October 12, 2016

MODENA STREET (HARRISON TO SPRING) SIDEWALK

Addendum #1

SHEET X-3

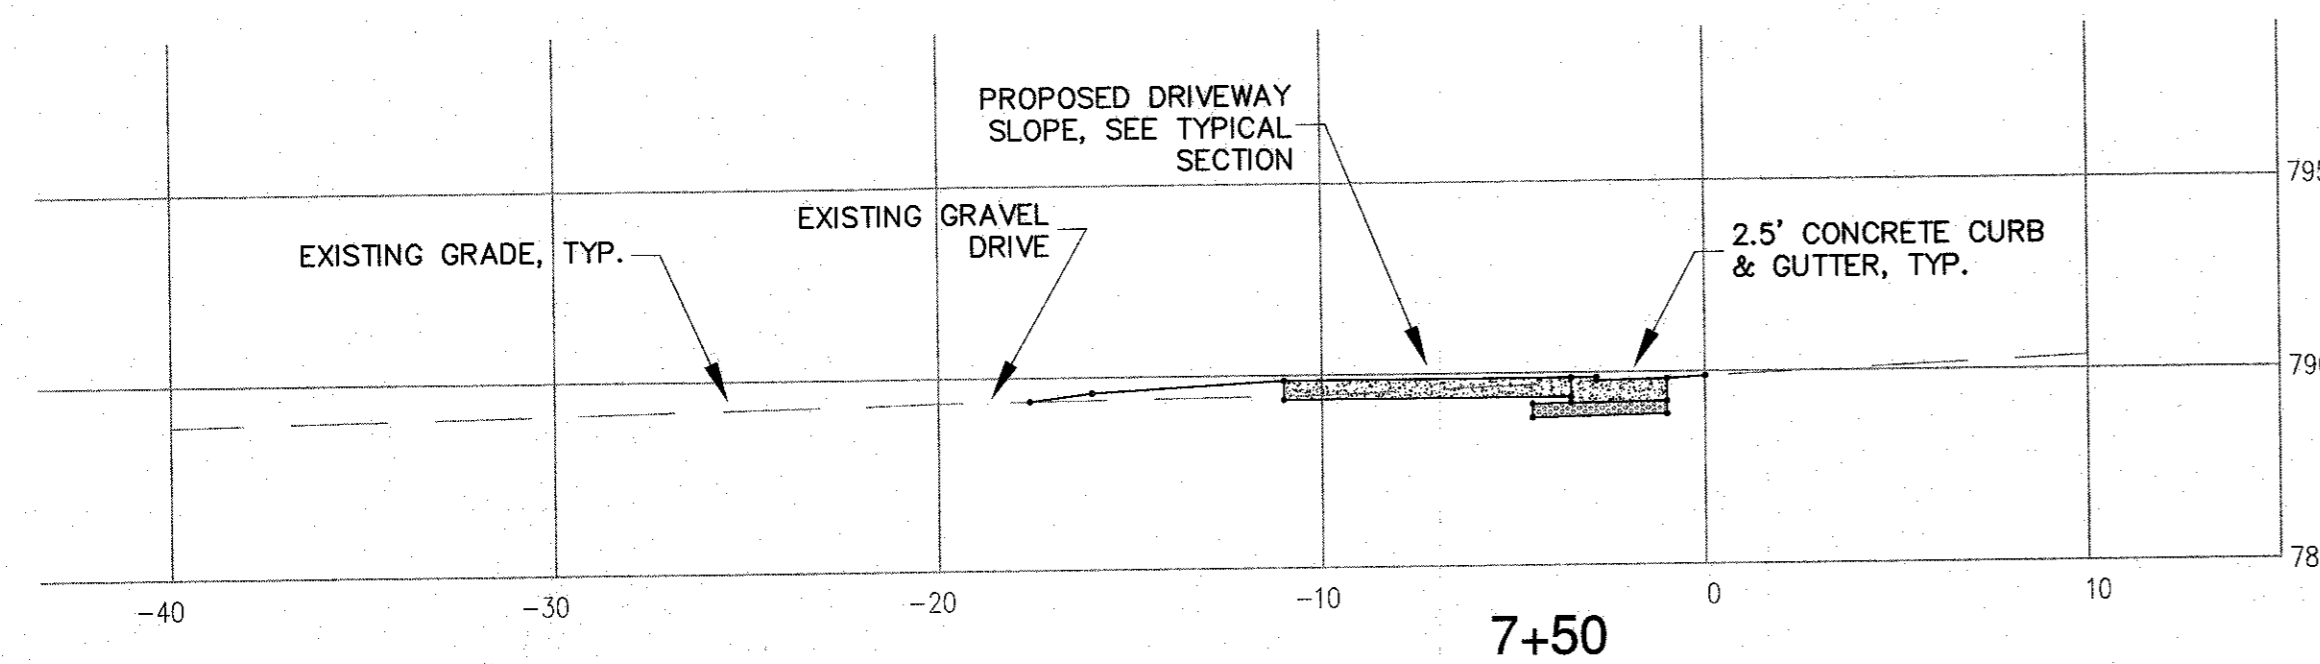
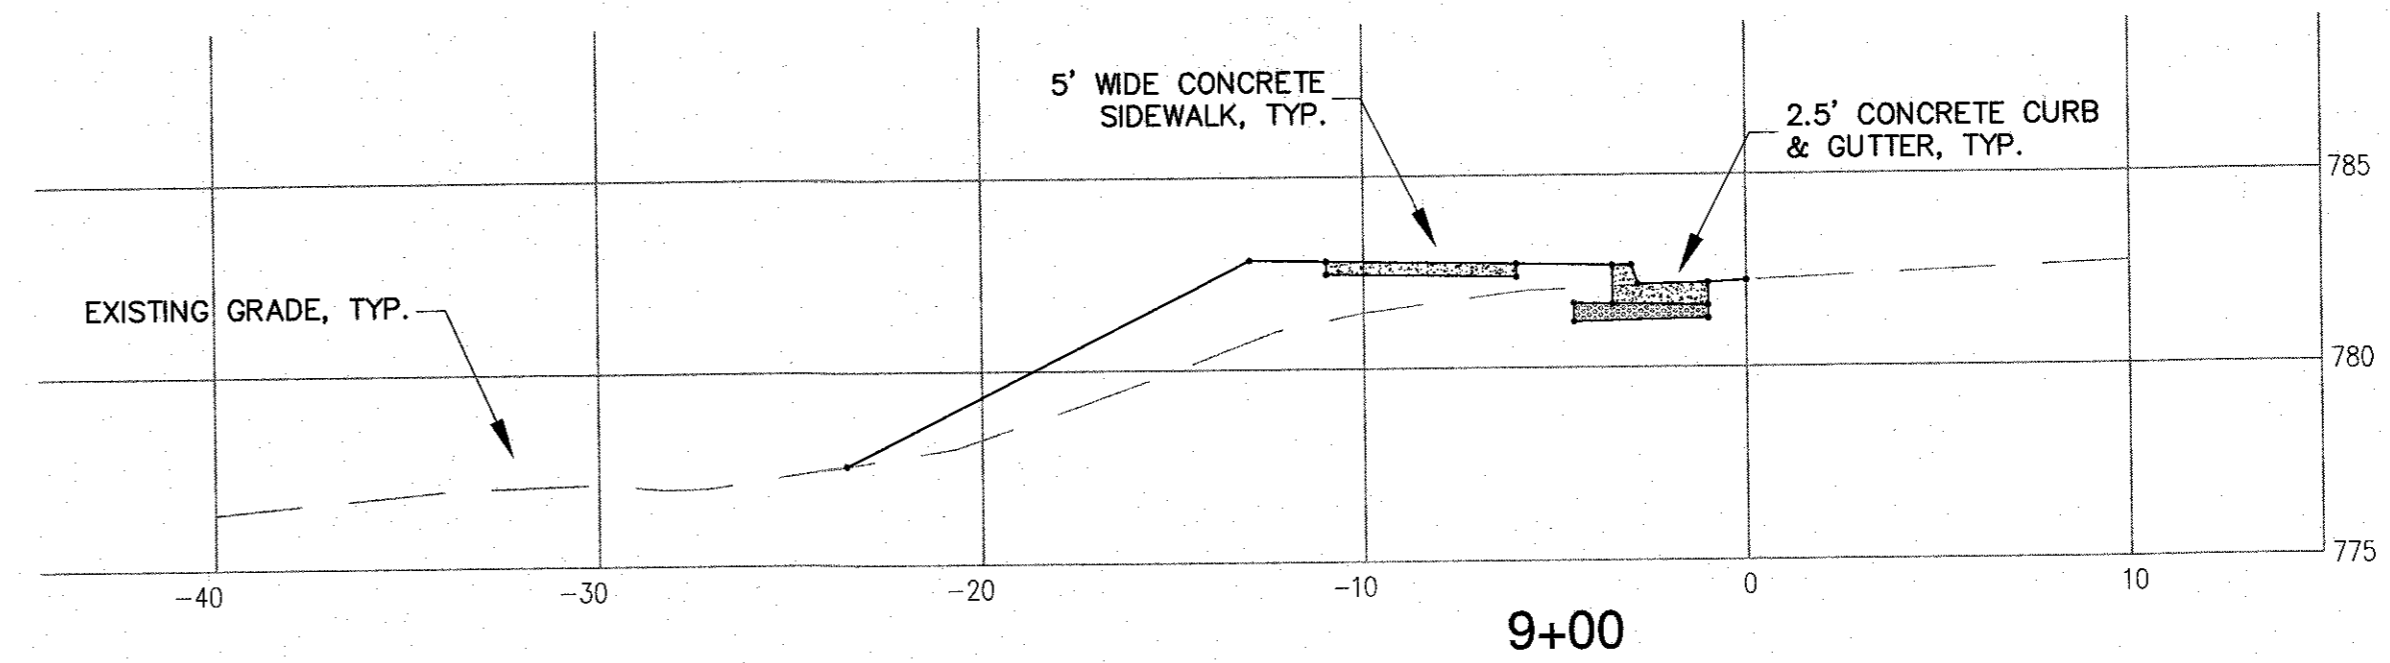
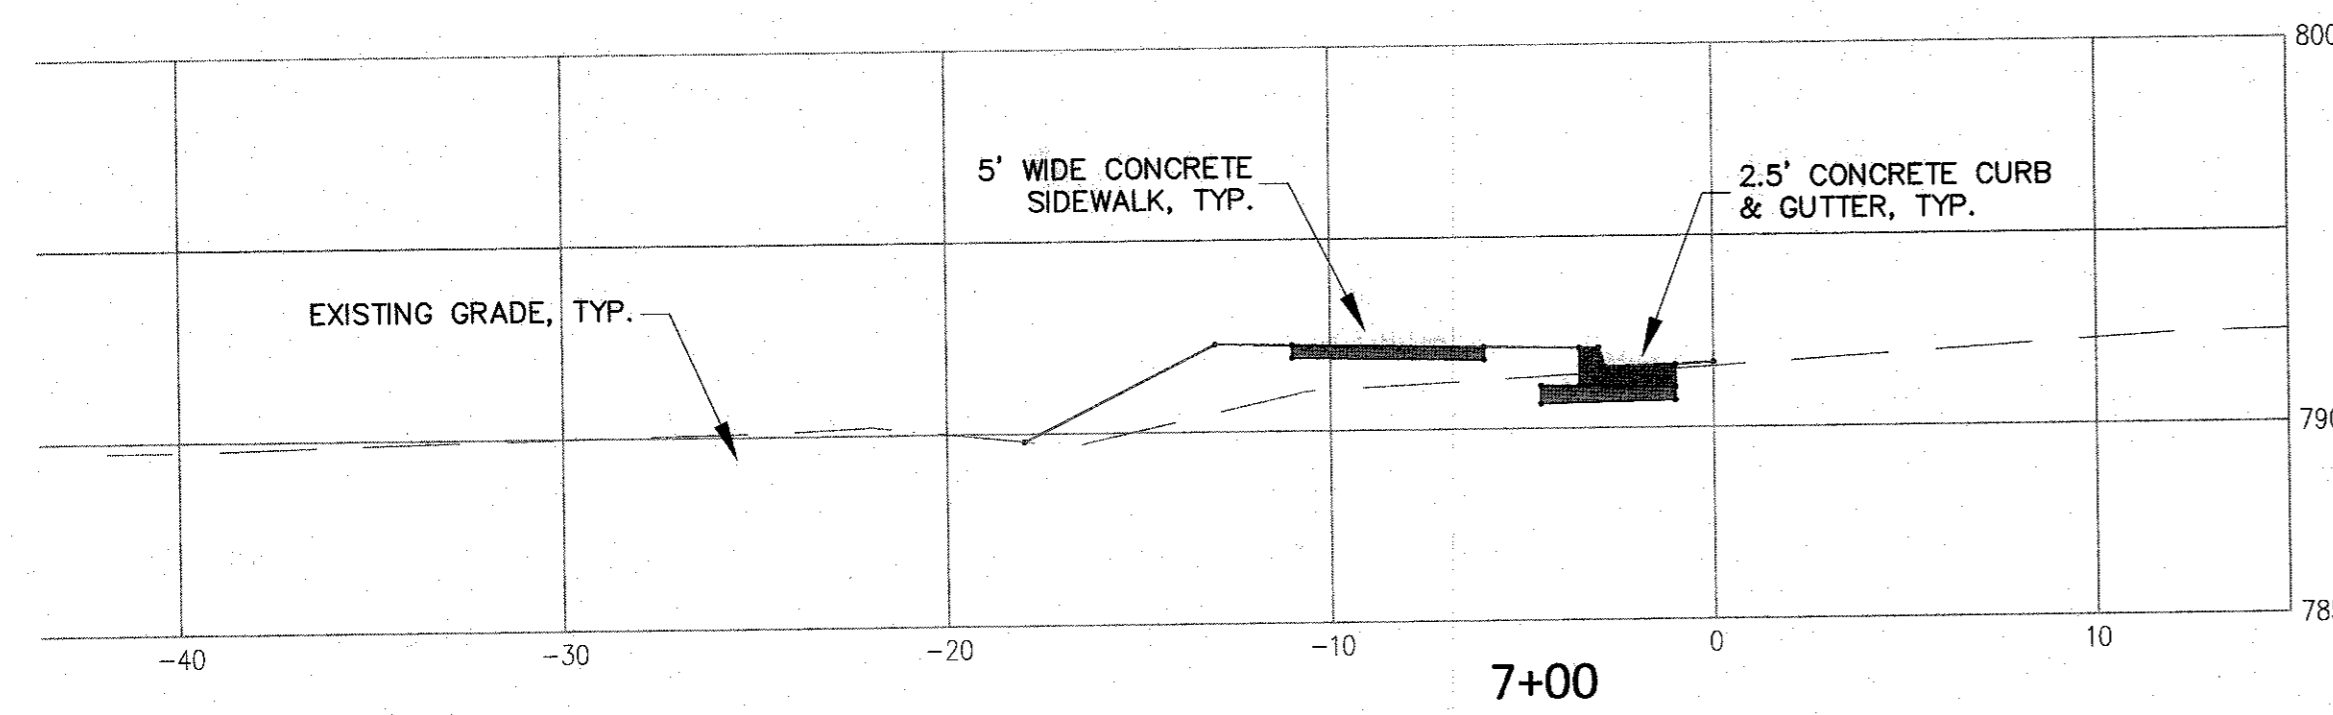
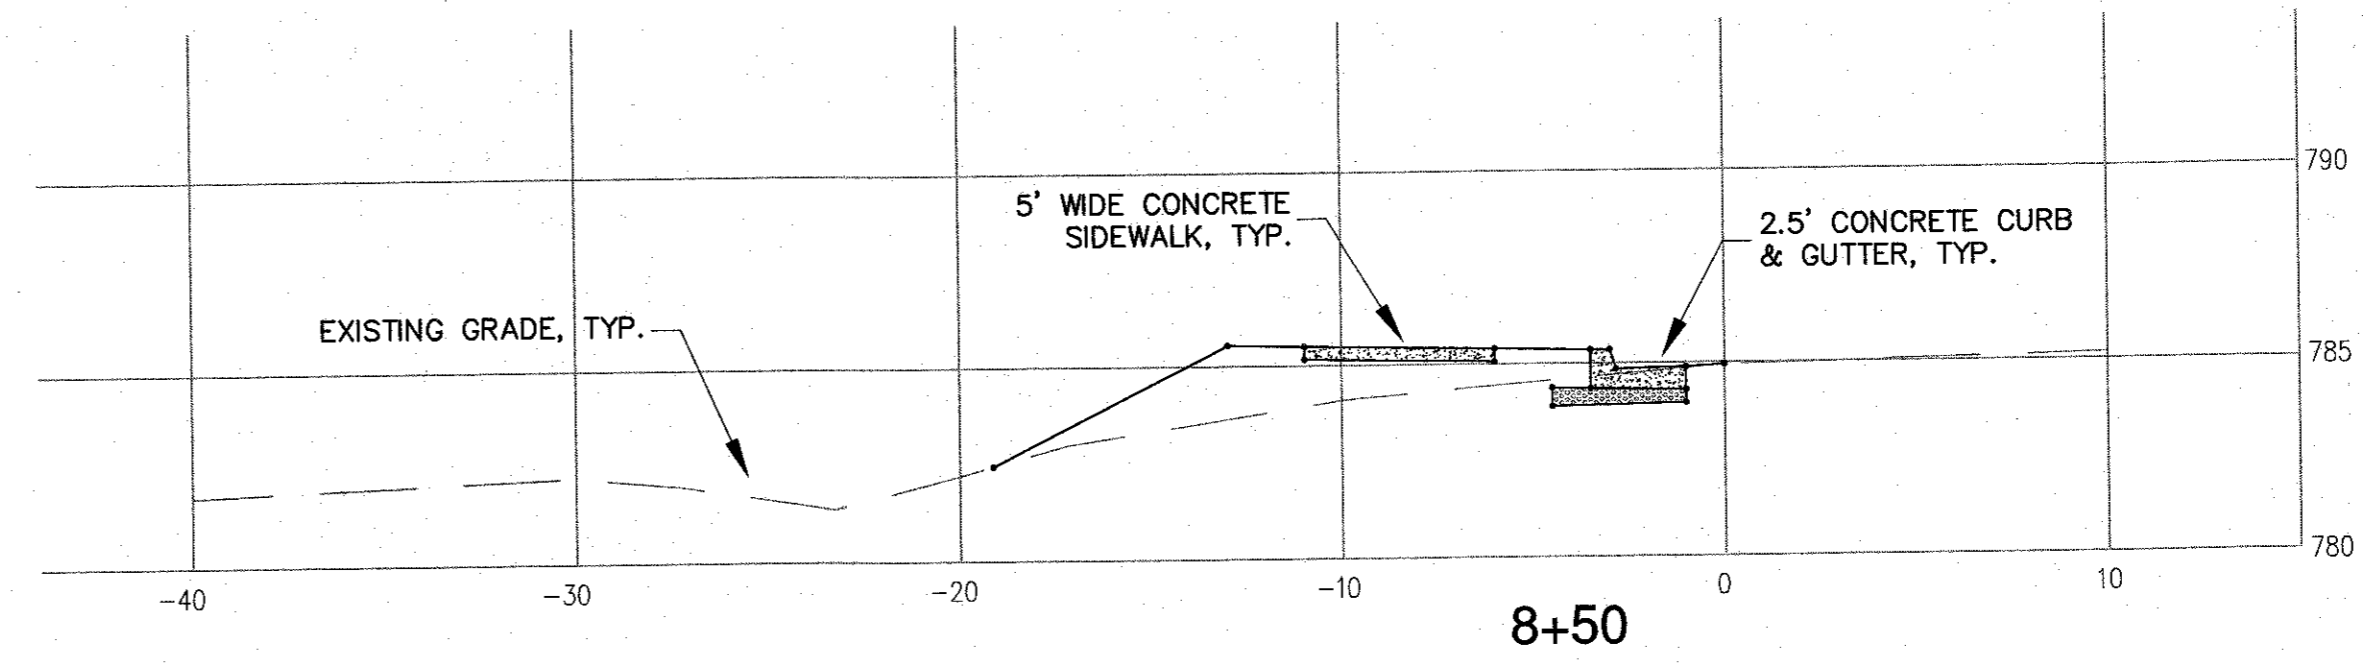
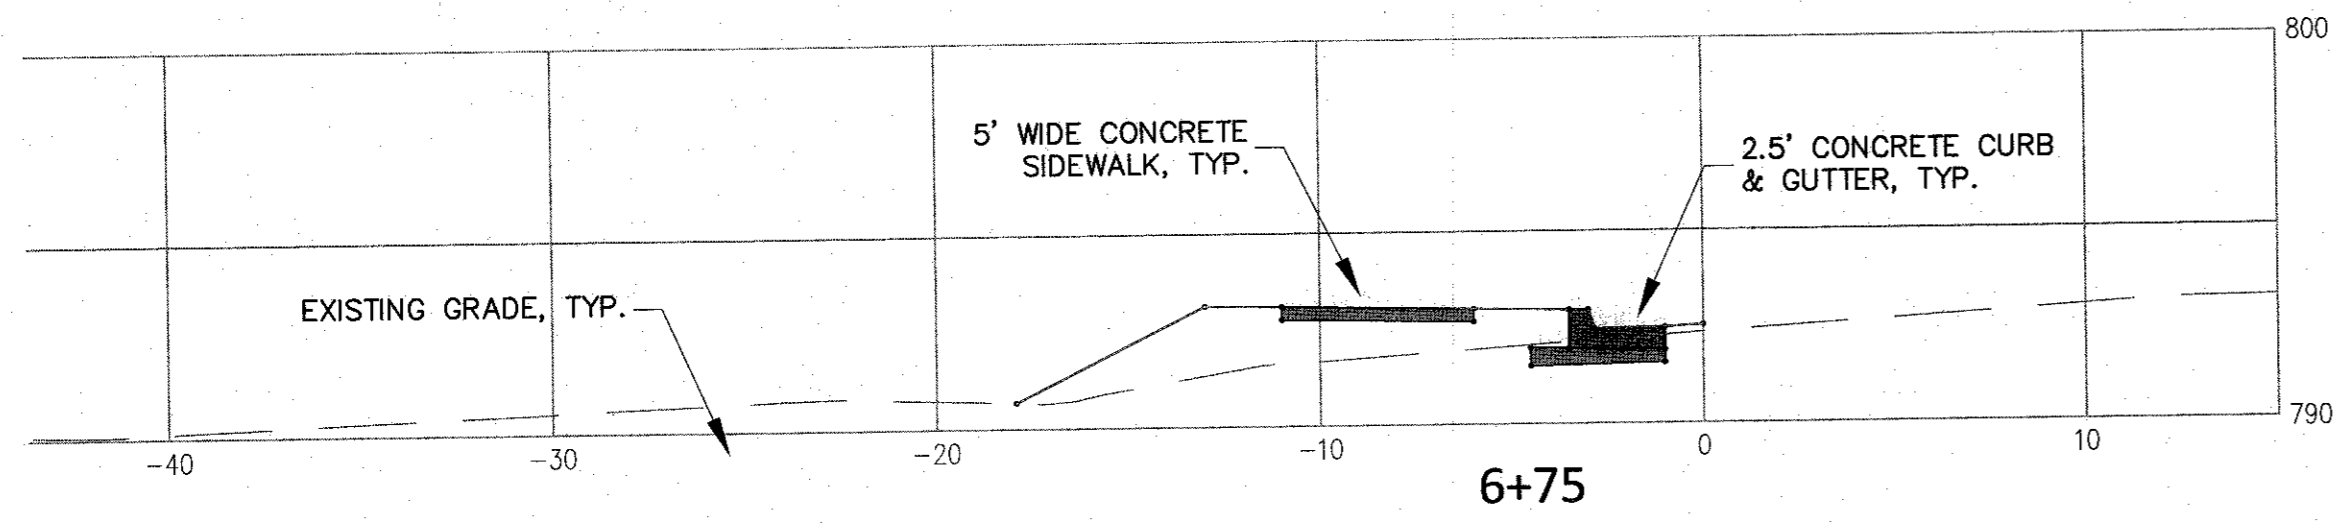
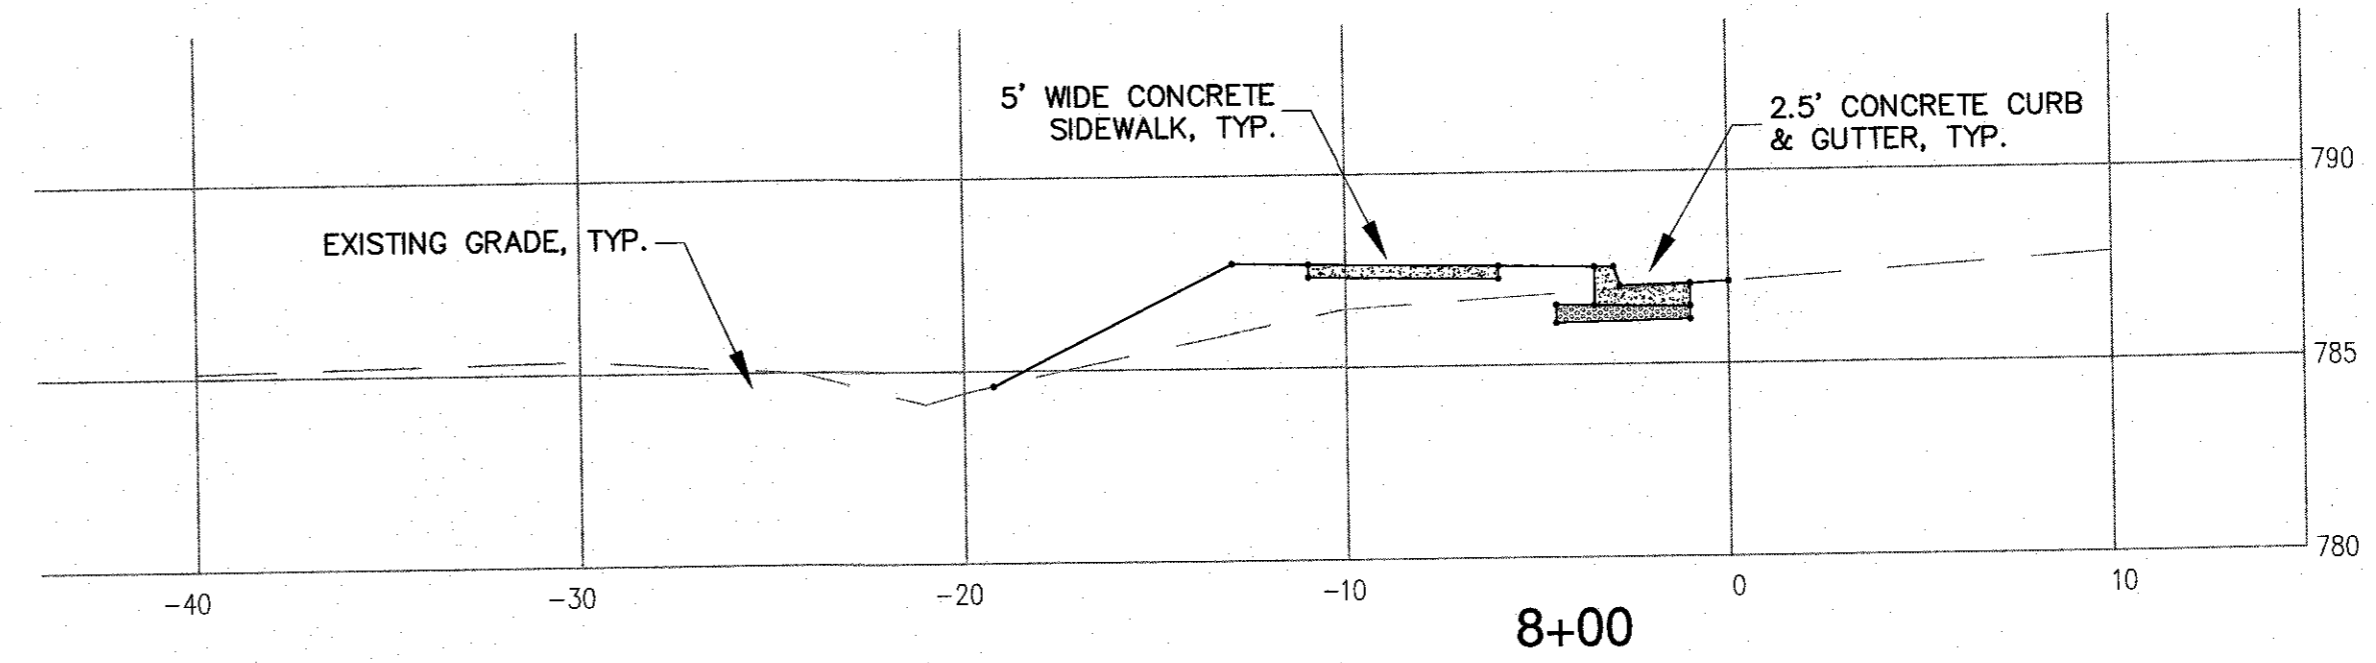
- Additional cross sections for proposed sidewalk from Sta. 0+00 to 9+00 and 13+50 to 16+09. (X-1 thru X-5) are attached to this Addendum. If you have already picked up your bid documents and plans, and would prefer a hard copy of the revised sheets, please contact caryr@cityofgastonia.com.
